LETTER REGARDING THE FLORIDA DEPARTMENT OF ENVIRONMENTAL PROTECTION COMMENTS FOR THE ORLANDO POLICE DEPARTMENT CRIME SCENE FACILITY WAREHOUSE BUILDING RENOVATION AND EQUESTRIAN FACILITY RELOCATION WORK PLAN AT STUDY AREA 2 NTC ORLANDO FL

6/6/2016

Re: Orlando Police Department Crime Scene Facility Warehouse Building Renovation and Equestrian Facility Relocation, Herndon Annex, Orlando, Florida

EXHIBIT "A"

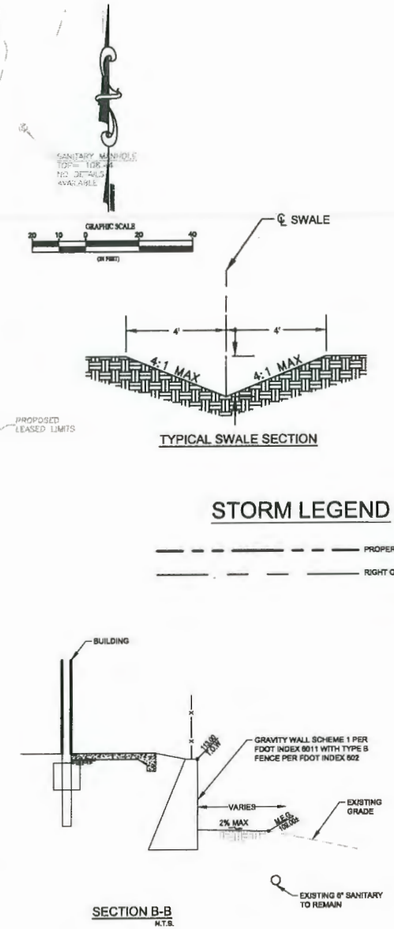
The Department has determined that adhering to those specifications provided in the April 7, 2016 letter (attached) for the installation of the communications duct and structural column footers should be protective of human health and the environment. For the purpose of satisfying the Department's obligation under the above identified deed, the Department is providing this written authorization to conduct the proposed work. The temporary authorization to conduct the proposed work is specific to the installation of the underground communications duct and the structural column footers for the stable and does not provide a release of any environmental deed restriction as provided for on page 14, lines 41 and 42 and page 15, lines 1 through 10, of the subject deed. Please note that this letter does not provide authorization or approval for the work

Site improvements to support the renovated warehouse and equestrian facility have been revised to minimize any potential impact to the existing buried debris/landfill area. Exhibit A shows the revised grading plan for the equestrian site. We no longer have any "cut" sections within the limits of the landfill. Also, we are no longer expanding the pond adjacent the site for stormwater treatment. This treatment volume is now being generated in a connected retention pond just northeast of the site which is located well away from the landfill area (see Exhibit B). The material removed from this pond will be tested and used to provide fill on the equestrian site. This retention pond revision also alleviates the need to dig and relocate the existing wastewater and domestic water lines which would have potentially impacted the buried landfill. The only potential impacts to the landfill area now are the communications duct on the west side of the site and column footers for the stable (horse barn) structure (Exhibit A). We plan to trench the 4" communications duct (30"-36" deep) and excavate for the structural column footers (less than 4' deep) with a backhoe. Material removed to install these improvements will be placed back in the excavated area and compacted. These revised site improvement plans are currently being submitted to the City's Permitting department for review and approval.
